DUANE ARNOLD ENERGY CENTER

AMENDMENT TO FACILITY OPERATING LICENSE

Amendment No. 136
License No. DPR-49

SAFETY EVALUATION BY THE OFFICE OF NUCLEAR REACTOR REGULATION
SUPPORTING AMENDMENT NO136TO FACILITY OPERATING LICENSE NO. DPR-49

DAEC Nuclear Plant Staffing
Figure 6.2-1

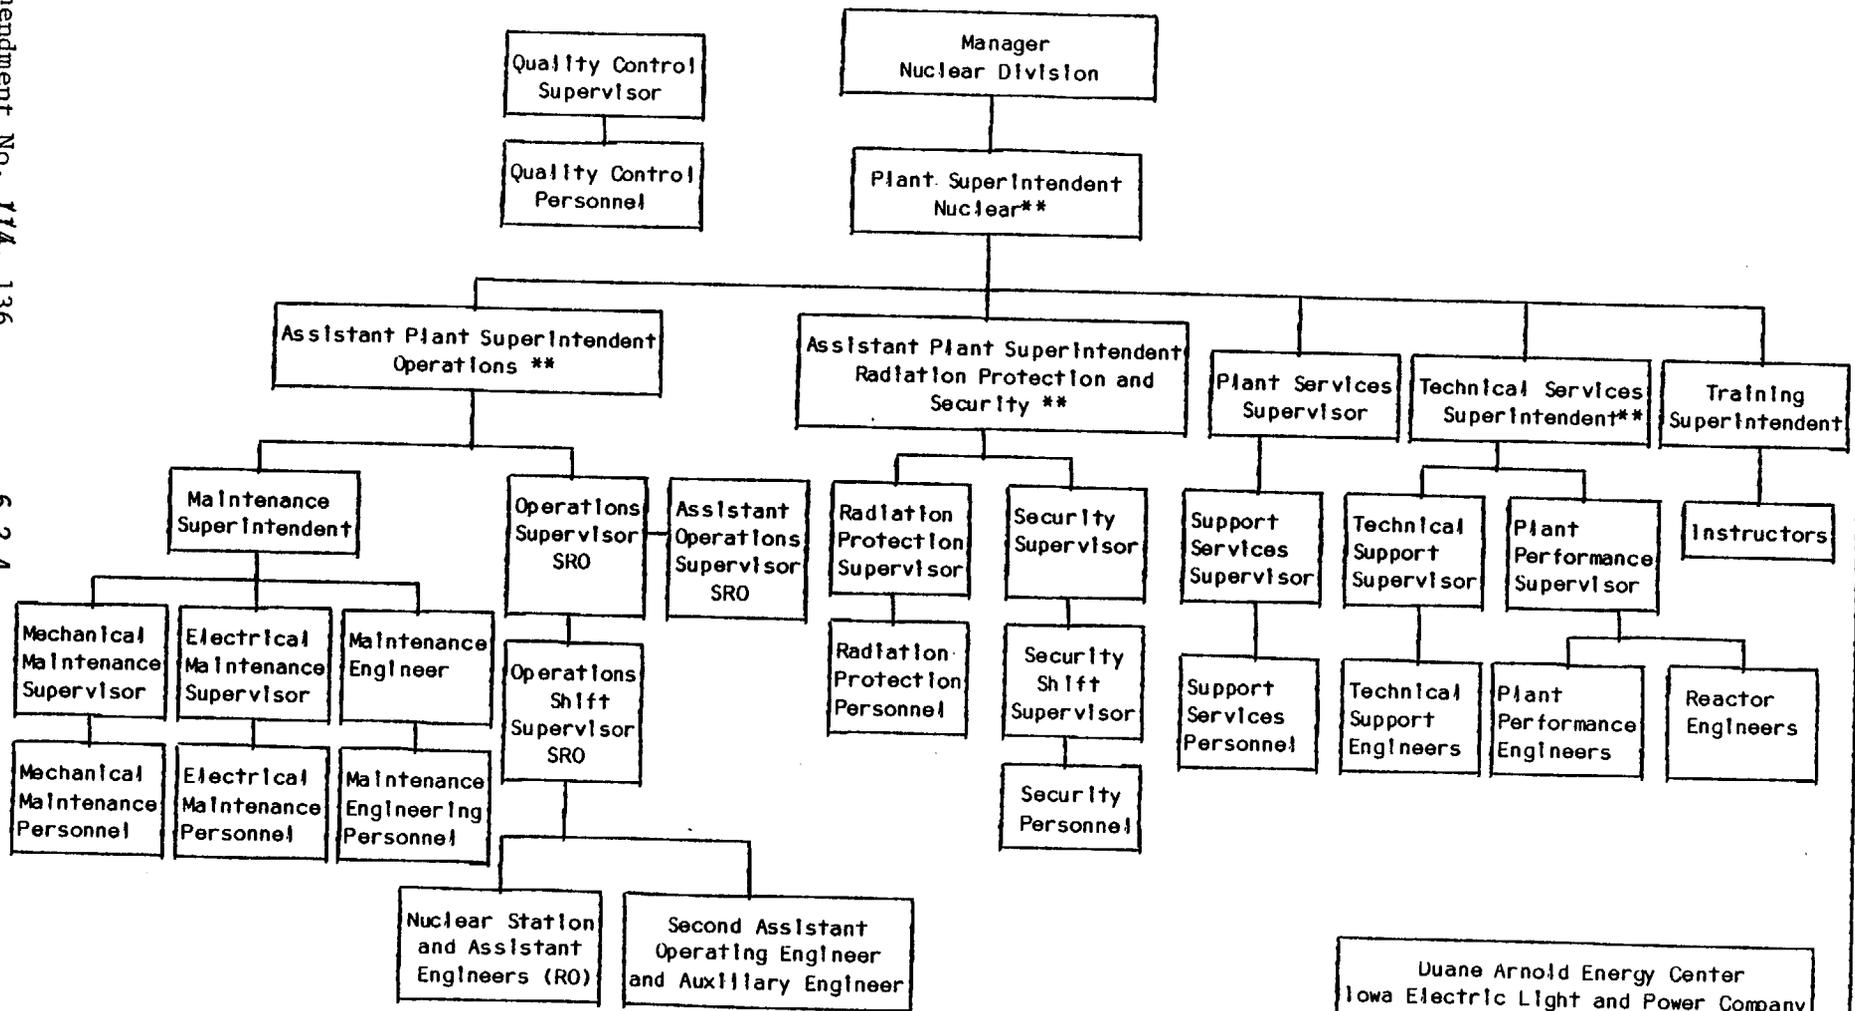
The proposed changes, as shown on the organization chart in Figure 6.2-1, concern two main areas. One change rearranges a portion of the DAEC plant staffing. The other change involves a change to the supervisory relationship between the site management and the off-site Nuclear Generation management.

The position of Assistant Plant Superintendent-Technical Support will be eliminated and separated into two positions--the Plant Services Supervisor and the Technical Services Superintendent. The Support Services Supervisor and the support services personnel will now come under the direction of the Plant Services Supervisor. The Technical Support Supervisor, the Plant Performance Supervisor and their engineers will be under the direction of the Technical Services Superintendent, who will report directly to the Plant Superintendent, Nuclear. This separation of supervision into the areas of Plant Services and Technical Services should enhance overall management control and should improve the effectiveness of the plant staffing.

The other proposed change to the organization chart, Figure 6.2-2 on page 6.2-4, will have the Plant Superintendent, Nuclear reporting directly to the Manager, Nuclear Division rather than to the Director, Nuclear Generation, who reported to the Manager, Nuclear Division. The position of Director, Nuclear Generation will be eliminated. The staff finds that the change will provide a direct communication link between the Manager, Nuclear Division and the Plant Superintendent, Nuclear.

- (4) On page 6.2-4, the DAEC Nuclear Plant Staffing chart is modified to reflect the site organization changes and the acronym changes as described above.

- (5) On page 6.2-4, the two-asterisk note is reworded to clarify which positions may be used to meet the requirements of ANSI N18.1-1971.
- (6) On page 6.5-1, item 6.5.1.2 is reworded to reflect the effects of the staffing chart changes on the composition of the Operations Committee.
